**RE: Vivian Sand Extraction Project (File # 6119.00) – Notice of Revised Extraction Plan**

**Revised Extraction Plan**

**Our Reference**  
Project No. 60640258Laura Weeden P. Eng.  
Sio Silica Corporation  
Suite 1930, 440-2<sup>nd</sup> Ave SW  
Calgary, AB T2P 5E9**RE: Vivian Sand Extraction Project (File # 6119.00)– Revised Extraction Plan Environmental Assessment**

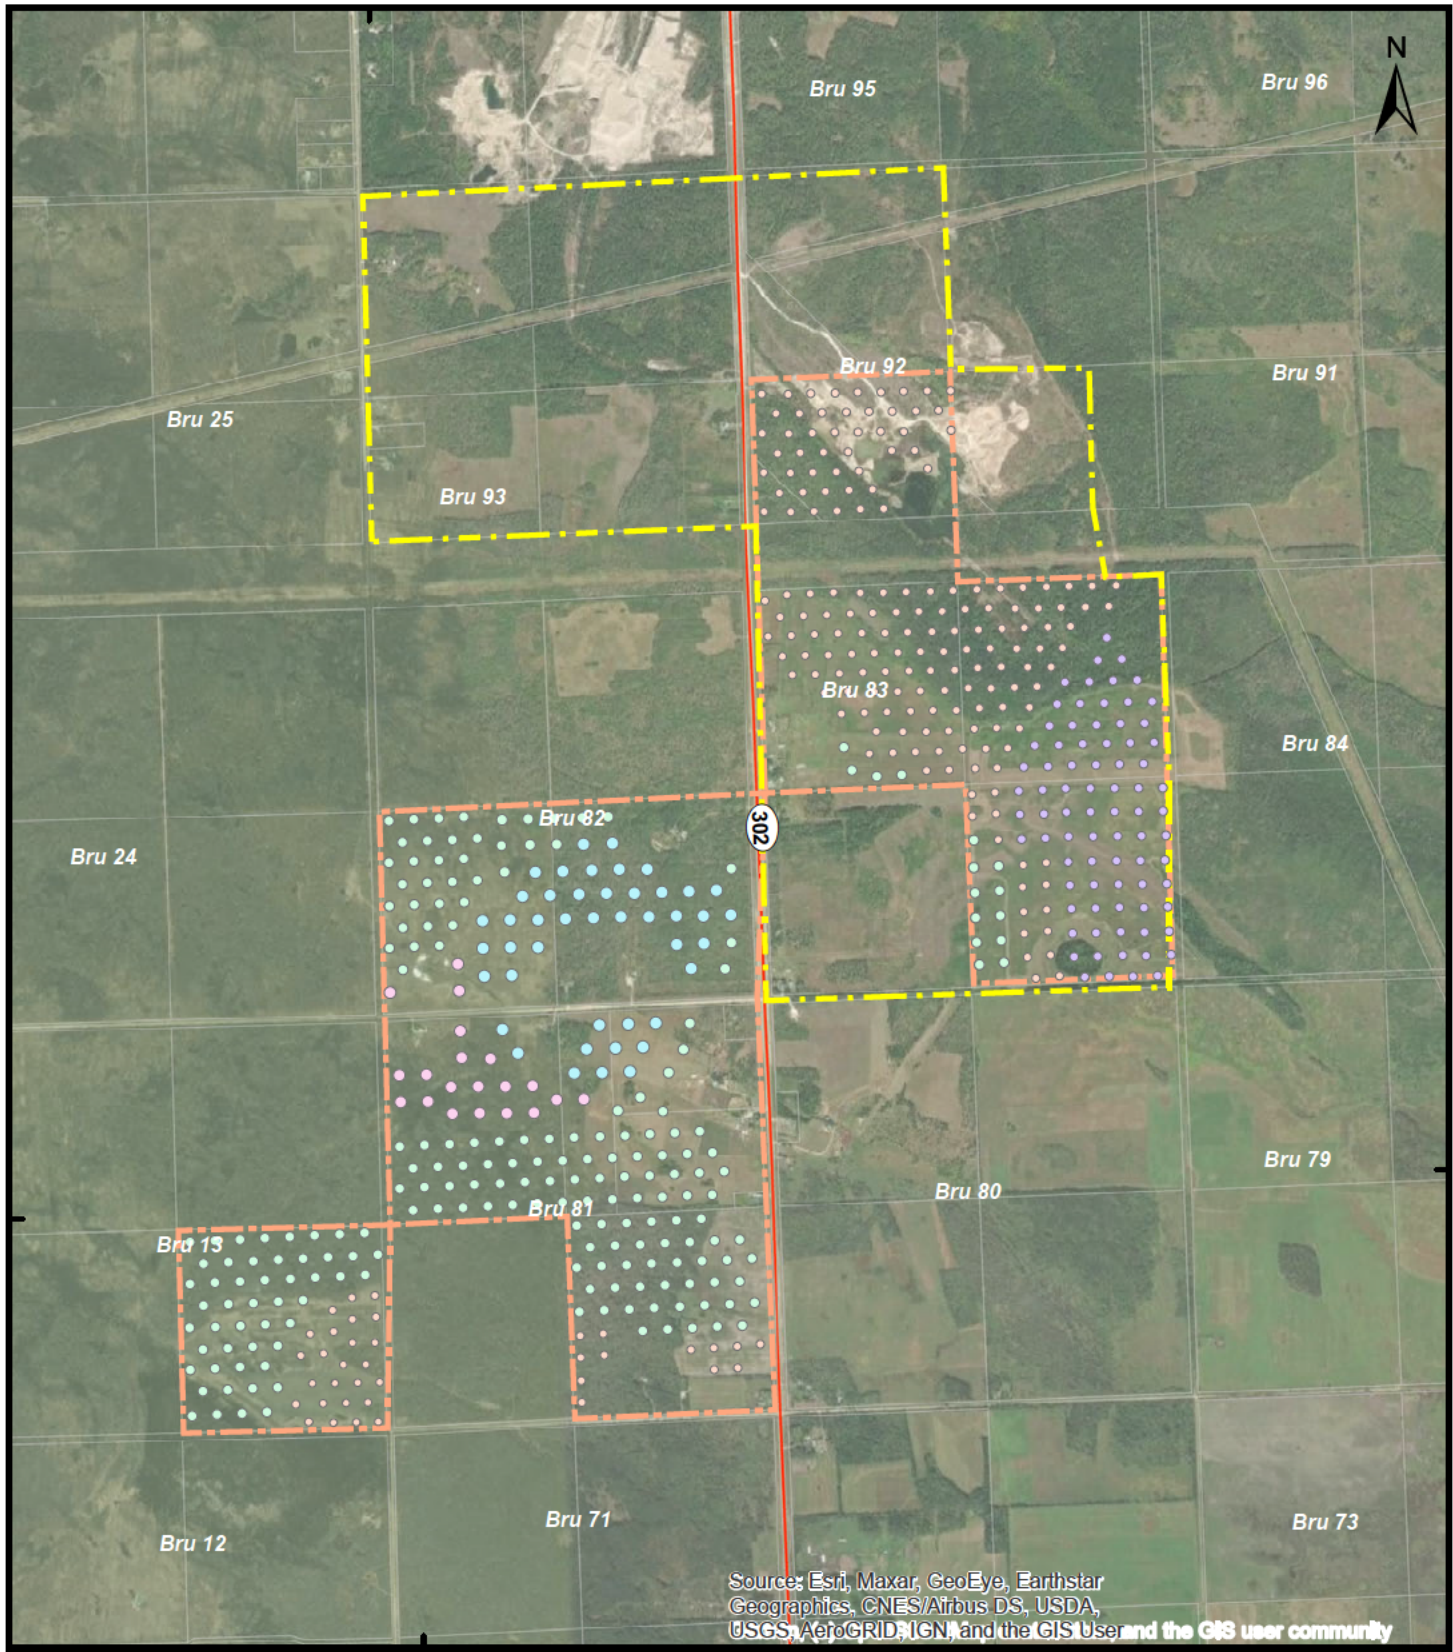
The primary benefit of this revised extraction plan is that the overall number of wells have been reduced by over 400 wells compared to the original extraction plan. Well clusters are also reduced from seven wells to a variable number of wells, but less than six, depending upon cap rock thickness in the extraction area. For example, some clusters are now as few as one single well while others may be as high as five wells. Please refer to the new Extraction Plan figure shown in Attachment A.

This revised Extraction Plan also includes the exclusion of some previously identified mining areas, as represented by the cross hatching in the revised Extraction Plan figures (Attachment A). The total land surface that has been removed from the original proposed extraction area has been reallocated a short distance away to Bru 82 claim SV12665, S ½ 19-010-08E, Bru 81 claim SV12664, N ½ & SE ¼ 18-010-08 E1 and Bru 13 claim SV12565, SE ¼ 13-010-07 E1 and does not exceed the total original land surface area.

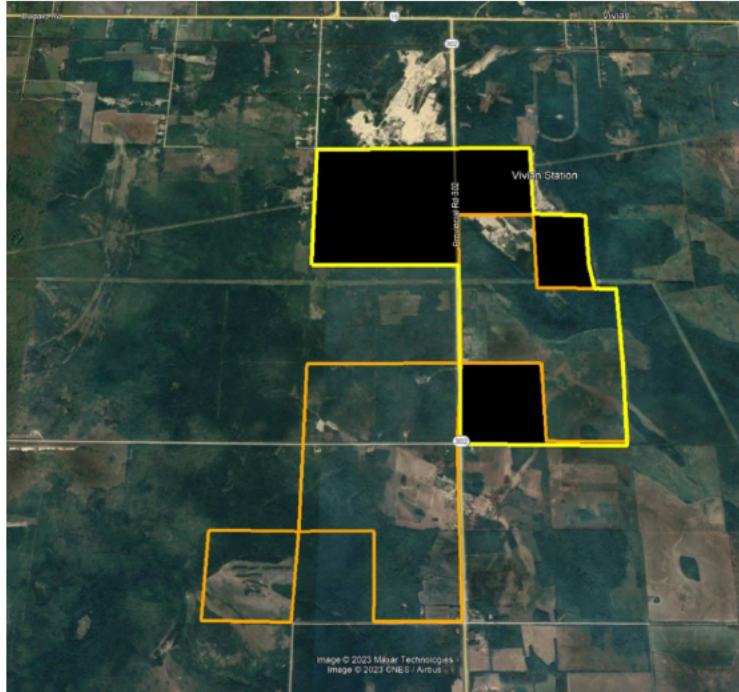
- Overall number of wells has been reduced (by over 400 wells) compared to the original extraction plan;
- The number of wells in each well cluster has also been reduced from seven wells to a variable number of wells, but less than six, depending upon cap rock thickness in the extraction area;
- Project Site boundary within which sand extraction activities will be conducted has been revised to exclude some from the original proposed extraction area, and has been reallocated a short distance away as shown in the figures below;
- The overall revised Project Site area (633 ha) is slightly smaller than the original Project site area (649 ha).

A comparison of the 'old' (yellow boundary) vs. 'new' (orange) Project Site boundary is provided below:

This image below overlaps the 'old' (yellow boundary) and 'new' (orange) Project Site boundaries for clarification (blacked-out areas are now excluded from the 'new' Project Site boundaries).
